**Re: Kiddie Academy
7010 Alameda Blvd. NE
Request Temporary C.O. - Accepted (C19D961)
Engineer Stamp Dated 11/14/16**

ALAMEDA & LOUISIANA
COMMERCIAL DEVELOPMENT
GRADING & DRAINAGE PLAN

C-1

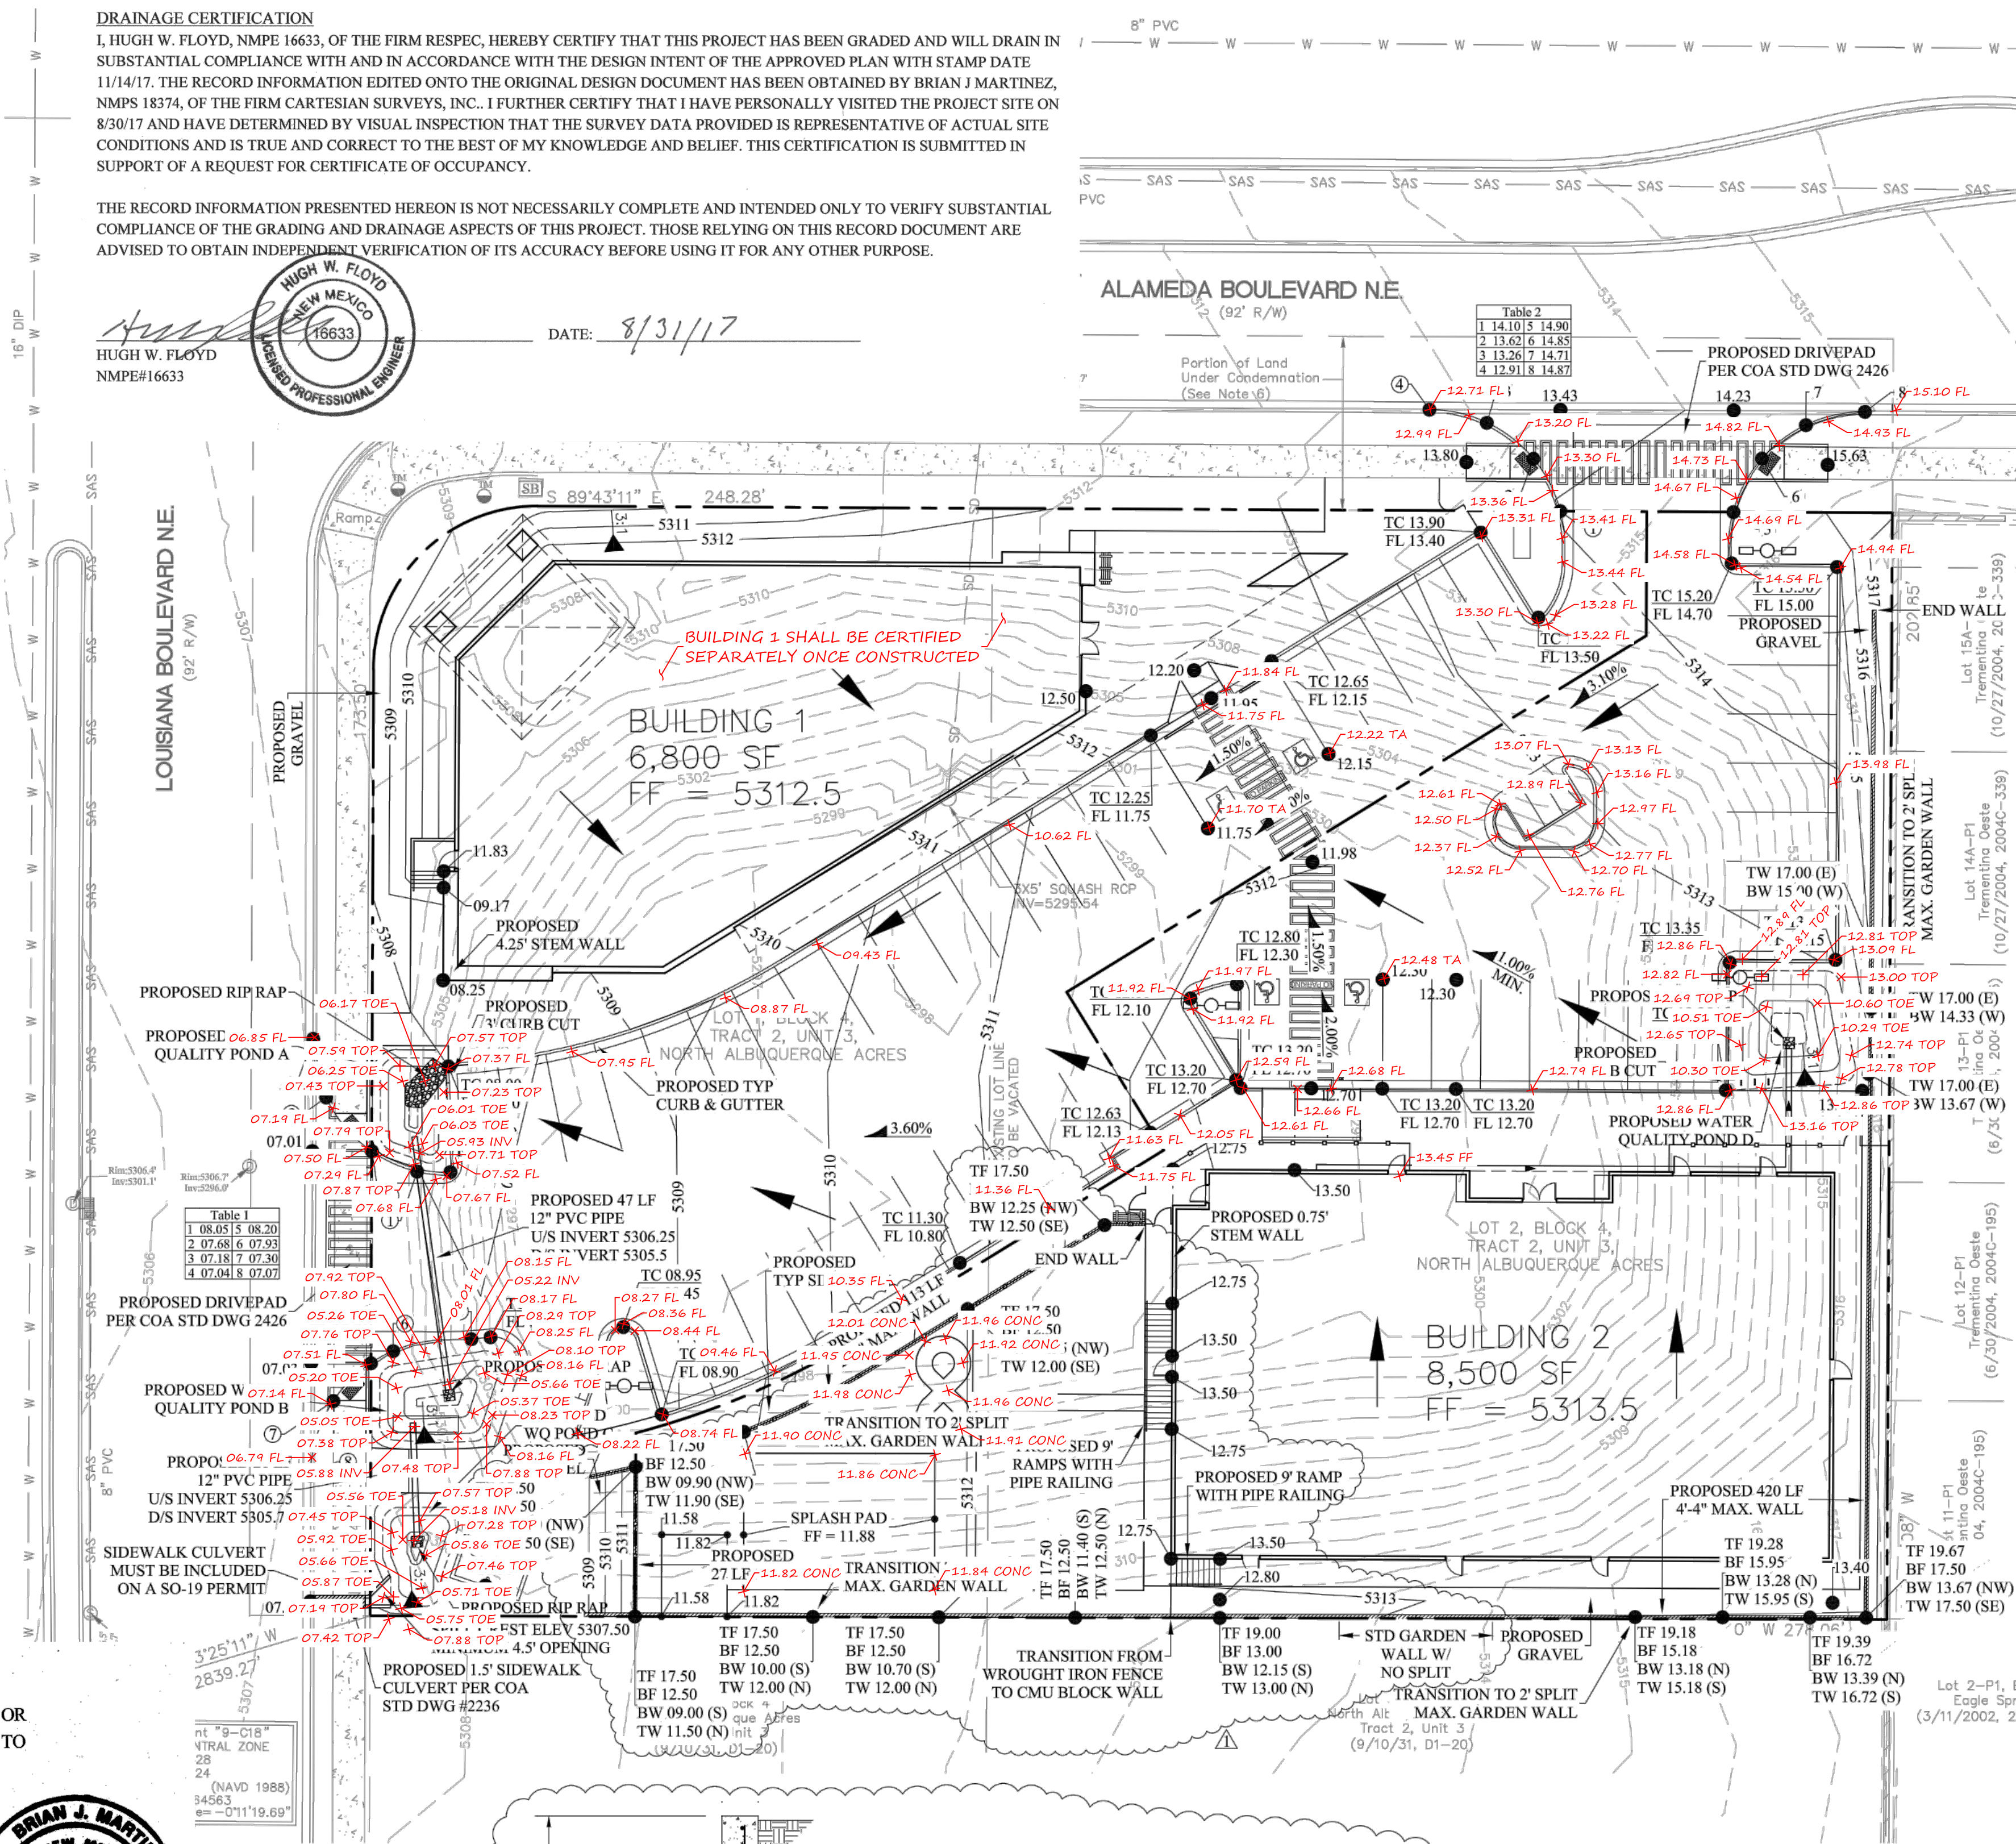
- Private Drainage Covenant Required prior to permanent Certificate of Occupancy.
